Proposed Revisions to a Standard Plans Index

Index Number: 120-001

Index Title:
Embankment Utilization

Summary of the changes:

INDEX
120-001

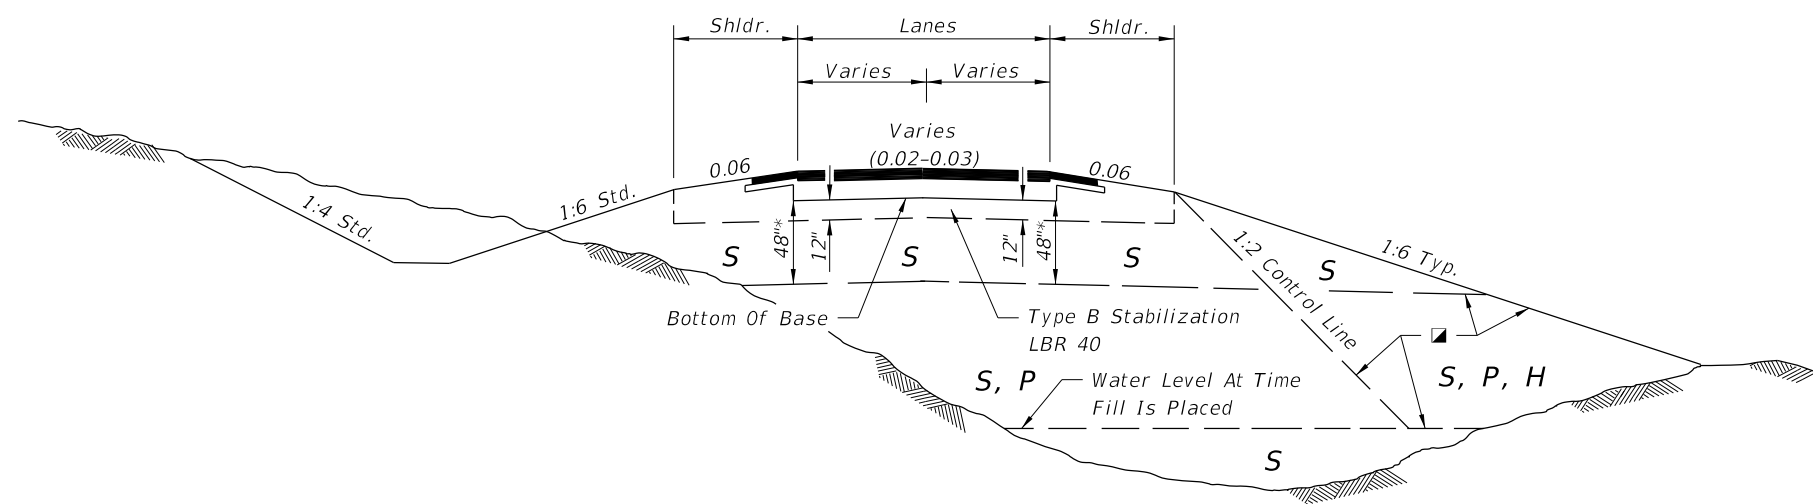
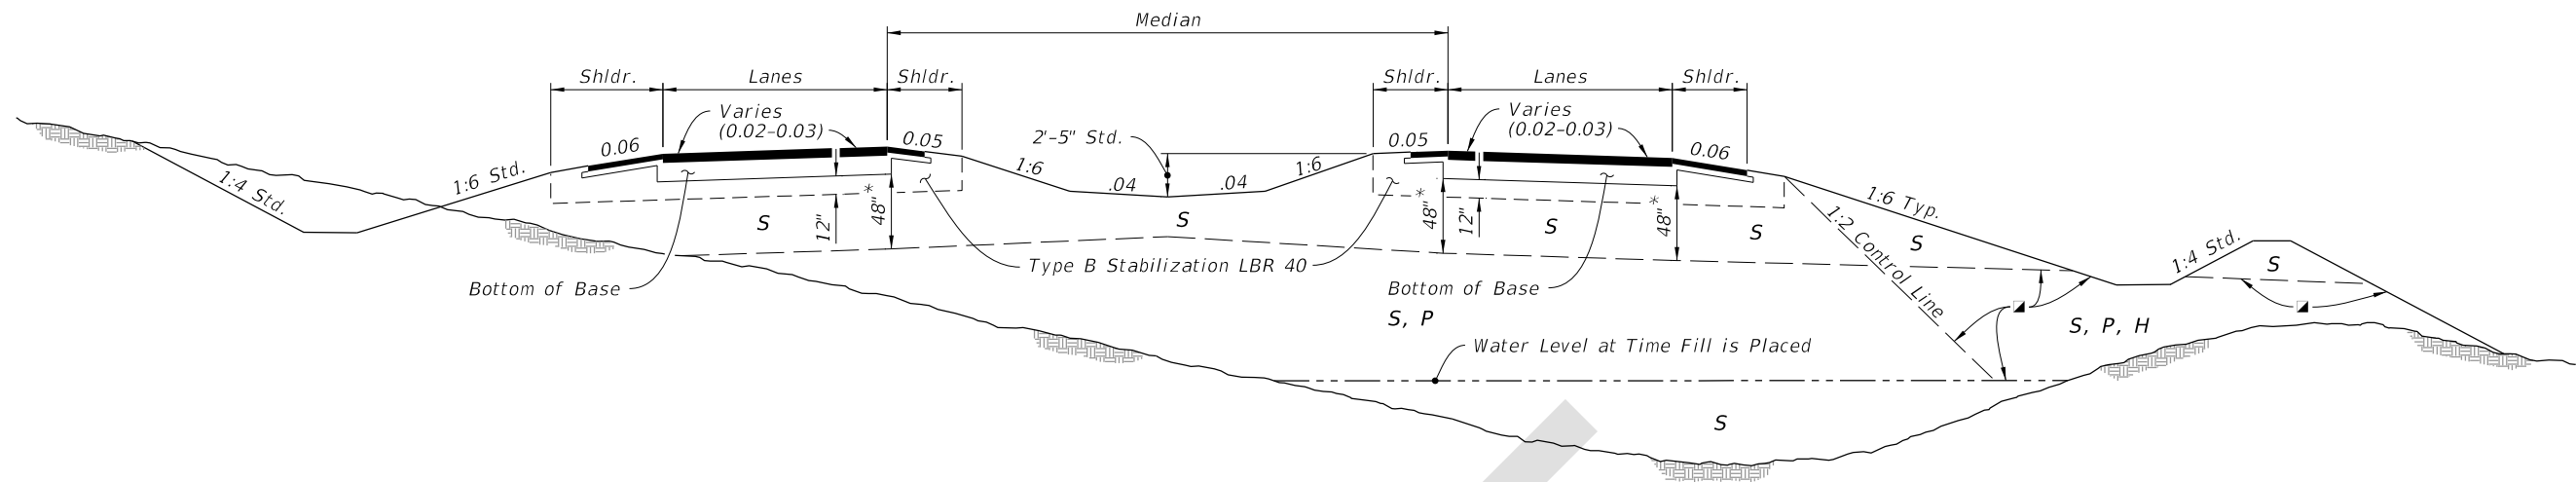
Update Note 4 to reference proper testing

Specification 120 and Index 120-001 have contradicting testing information. Change Index to "Perform tests in accordance with FM 1-T 267."

- Select (S) soils having an average organic content of more than two and one-half (2.5) percent, or having an individual test value which exceeds four (4) percent, are not permitted in the subgrade portion of the roadbed. Select (S), Plastic (P), or High Plastic (H) soils having an average organic content of more than five (5) percent, or an organic content individual test result which exceeds seven (7) percent, are not permitted in the portion of embankment inside the control line, unless written authorization is provided by the District Geotechnical Engineer; these soils may be used for embankment construction outside the control line, unless restricted by the Plans or otherwise specified in the Plans, provided they can be compacted sufficiently to sustain a drivable surface for operational vehicles as approved by the Engineer. Determine average organic content from the test results from a minimum of three randomly selected samples from each stratum or stockpile of a particular material. Perform tests in accordance with AASHTO T 267 on the portion of a sample passing the No. 4 sieve.

FM 1-T 267

- Select (S) soils having an average organic content of more than two and one-half (2.5) percent, or having an individual test value which exceeds four (4) percent, are not permitted in the subgrade portion of the roadbed. Select (S), Plastic (P), or High Plastic (H) soils having an average organic content of more than five (5) percent, or an organic content individual test result which exceeds seven (7) percent, are not permitted in the portion of embankment inside the control line, unless written authorization is provided by the District Geotechnical Engineer; these soils may be used for embankment construction outside the control line, unless restricted by the Plans or otherwise specified in the Plans, provided they can be compacted sufficiently to sustain a drivable surface for operational vehicles as approved by the Engineer. Determine average organic content from the test results from a minimum of three randomly selected samples from each stratum or stockpile of a particular material. Perform tests in accordance with FM 1-T 267.
